INTRODUCTION

This errata provides information applicable to the following products:

- 1-002-0017 programming adapter Rev.B or earlier

STEP1

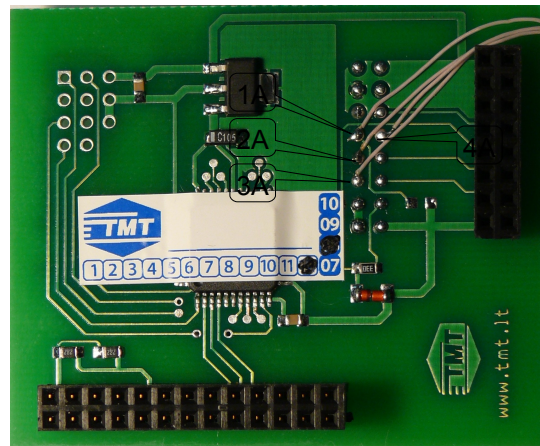
Remove this resistor
